Agenda Item # 12

SUB-003240-2025 & ZON-UDC-003426-2025

Star Light at Cottage Hill Subdivision

APPLICATION NUMBER	12	DATE	Augus 21, 2025	 NTS
APPLICANT	Star Light at Cottage Hill Subdivision			
REQUEST	Subdivision, Rezoning from R-1 to R-3

SITE PLAN

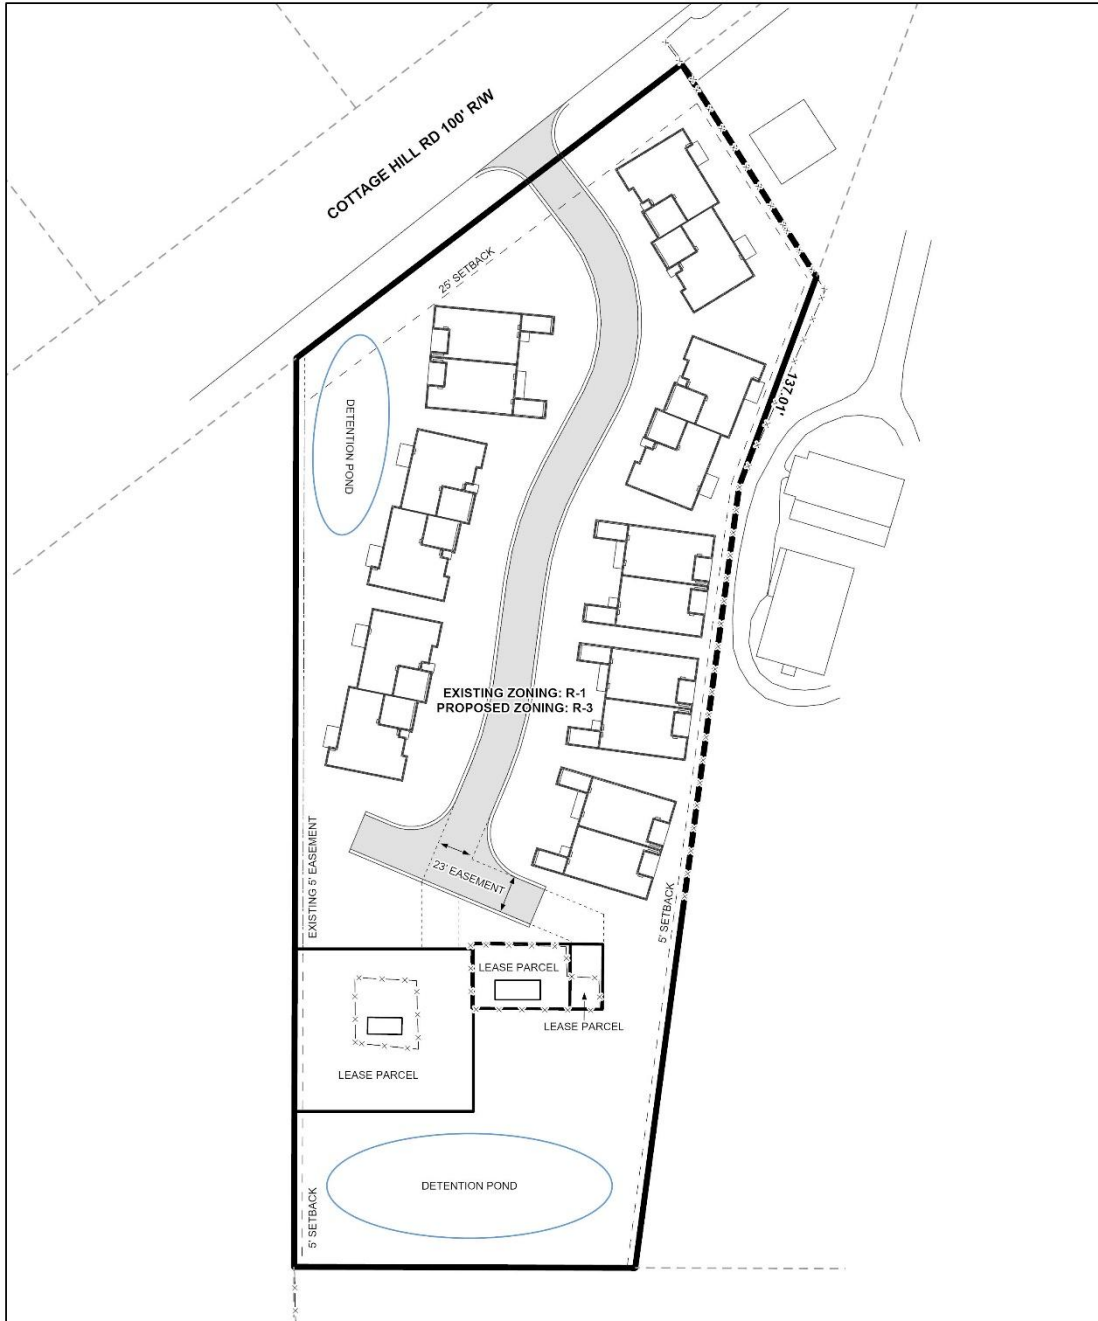
The preliminary plat illustrates a single proposed lot, labeled Lot 1, and two (2) lease parcels, each of which exceeds 3,000 square feet in area and are developed with a telecommunications tower and associated equipment. Under current regulations, any parcel 3,000 square feet or more must be established as a legal lot of record. Although the lease parcels existed in their current configuration prior to annexation, the concurrent

As the Subdivision request is for two (2) legal lots, the plat must be revised to clearly depict the configuration of both proposed lots, as staff cannot infer the intent of their design from the application materials provided.

The site fronts Cottage Hill Road, classified as a Minor Arterial Street, which requires a 100-foot-wide right-of-way at this location. Although the preliminary plat reflects a varying right-of-way width, internal mapping data and parcel records suggest that sufficient right-of-way exists. Therefore, if approved, the plat must be revised to clearly depict either the minimum existing right-of-way width or a dedicated 100-foot-wide right-of-way, whichever is greater.

A 23-foot-wide access and utilities easement is illustrated on the preliminary plat, providing access to both lease areas via a driveway through the proposed development. Given that traffic generated by telecommunications towers is generally limited to periodic maintenance, this configuration may be sufficient. Nonetheless, a waiver of Section 6.C.4. will be required for approval of the subdivision as proposed.

No information is provided for the second proposed lot, preventing staff from verifying whether it meets the minimum size requirements of the UDC. The revised plat must, therefore, include the area of the second lot in both square feet and acres.

Since the lease parcels do not front a public street, no front yard setback is required. Therefore, a waiver of Section 6.C.8. may be granted; however, this waiver should be limited to any proposed lot(s) lacking street frontage. The lease parcels will remain subject to the side and rear yard setback requirements outlined in Article 2 of the UDC for the applicable zoning districts.

As mentioned, an access and utilities easement is depicted on the preliminary plat. If approved, a note should be placed on the Final Plat stating no structures shall be constructed in any easement without permission of the easement holder.

Additionally, two existing easements are shown: a 30-foot-wide access easement along the west property line and a 20-foot-wide access easement near the east property line. Both easements are proposed to be vacated in favor of the newly illustrated access and utilities easements.

1. Revise the plat to clearly depict the configuration of both proposed lots;
2. Revise the plat to clearly depict either the minimum existing right-of-way width or a dedicated 100-foot-wide right-of-way, which is greater, along Cottage Hill Road;
3. Revise the plat to include the area of the second lot in both square feet and acres;
4. If the applicant instead intends to create three (3) legal lots to correspond with the boundaries of the lease parcels, the applicant must submit a revised plat, new mailing labels, and additional fees for the third lot.
